Appendix B Format for submissions

Maximising benefits from local generation

Submitter	Top Energy Network Ltd.
Submitter's organisation	<p>Top Energy is then northernmost electricity distribution business in New Zealand, and is consistently ranked in the top two EDBs for solar distributed generation percentage penetration (currently 7.1% of ICPs) with this rooftop solar ranging in size from 0.2kW to 440kW, averaging at 6.1kW. Together with the three large-scale solar generators currently connected to Top Energy's sub-transmission network, Top Energy is one of the most experienced EDBs in the country with regards to solar generation and its effects upon a distribution network.</p>

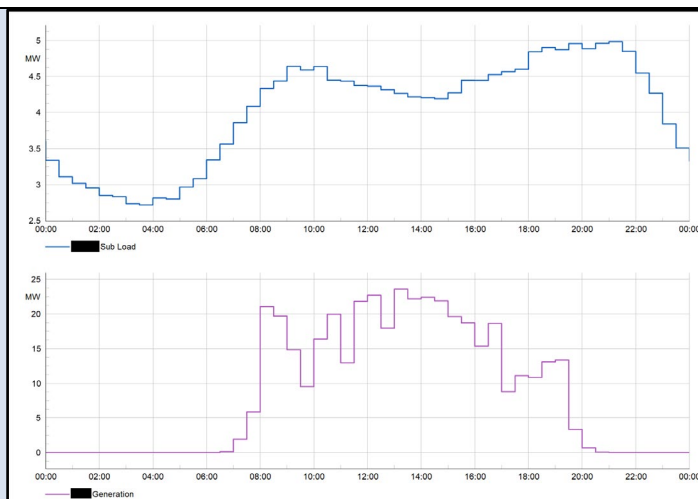
Top Energy has already observed at least one 11kV feeder having zero net real power flow at high solar generation times, and is likely to have reverse power flow on this feeder in the near future due to currently planned solar connections. Modelling of predicted generation and load changes over the next ten years show that constraints will occur on both Top Energy's sub-transmission network and on Transpower's Kaikohe-Maungatapere line, requiring Top Energy and Transpower respectively to constrain off large-scale generators to maintain thermal limits, spilling generation, an outcome that this consultation document says needs to be avoided (7.5) and a regulatory effect that is contrary to the EA's statutory objectives to promote competition and to promote efficient operation. Costs to undertake upgrades of the sub-transmission and transmission networks would have to be borne by Top Energy, and therefore all its customers, whilst only benefitting a subset of them.

Given the issues outlined above, implementing a default limit prior to the development of an industry standard poses significant problems. Development of said industry standard in a way that accurately reflects the varied conditions throughout New Zealand that takes into account the effects on the MV and HV networks, not just LV as currently discussed in the EEA guide is going to take substantially longer than the 4-month period proposed by the EA, and may not be feasible. For these reasons, this proposed change should be deferred for more in-depth consideration and consultation, with a date for the introduction of the ELAM of at least 12 months from now and default limits not introduced until this is available.

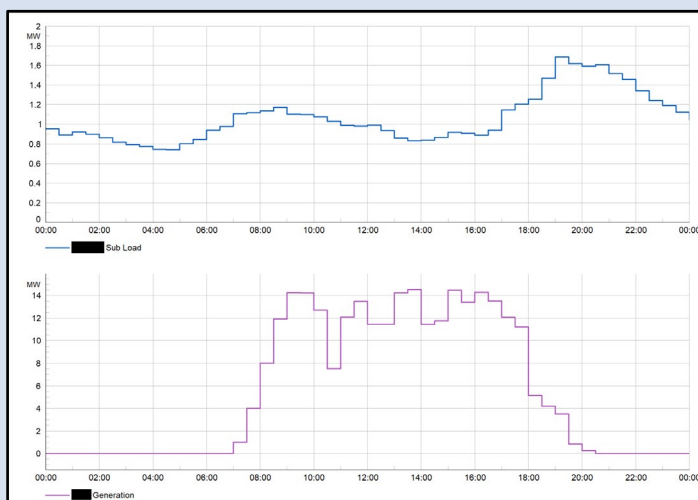
<p>Q17. What are your views on the objective of the proposed amendments?</p>	<p>Top Energy is supportive of the stated objectives but does not believe that the proposed changes will meet them.</p>
<p>Q18. Do you agree the benefits of the proposed amendments outweigh their costs? If not, why not?</p>	<p>Top Energy does not agree that the stated benefits will outweigh the costs, as the benefits the New Zealand electricity network might be overestimated whilst underestimating the costs.</p> <p>Addressing the benefits outlined in point 7.4:</p> <p>Point 7.4(a) asserts that increasing default export limits will improve returns to DG investors. Whilst this may be true for solar installers, the negative effects on large-scale, sub-transmission connected distributed generation due to constraints on the MV & HV networks outweigh this. Top Energy has modelled that at current growth rates, with connections sized at 10kW rather than 5kW, rooftop solar generation (currently 19MW) could grow to 50-60MW by 2034. At times of low summertime midday load (usually co-incident with times of high solar generation), such generation could see net export from the Kaikohe GXP of 160MW (when taking into account all currently connected and committed large-scale distributed generation), well above the Kaikohe-Maungatapere line's n-security capacity of 120MVA. Per the Special Protection Scheme that is being installed on this line, 40MW of the 64MW of large-scale solar being constrained off. At 38% of their generation capacity, the returns that these generators would be making are unlikely to be profitable.</p> <p>Point 7.4(b) asserts that DG will allow EDBs to manage load peaks and congestion, however this is not reflective of actual generation and consumption patterns, as shown in the below graph of a weekday in January comparing the generation curve of a Kaitaia-area solar farm with load curves at a major Kaitaia substation.</p>

As can be seen, load peaks after sunset, when solar generation has ceased. This is even more clear in the graph below comparing loads at a specific Top Energy substation with generation at a nearby solar farm on a weekend in January.

These curves demonstrate that contrary to the EA's supposition that load peaks will reduce as distributed solar generation penetration increases, load peaks will remain the same whilst introducing a generation peak in the middle of the day.
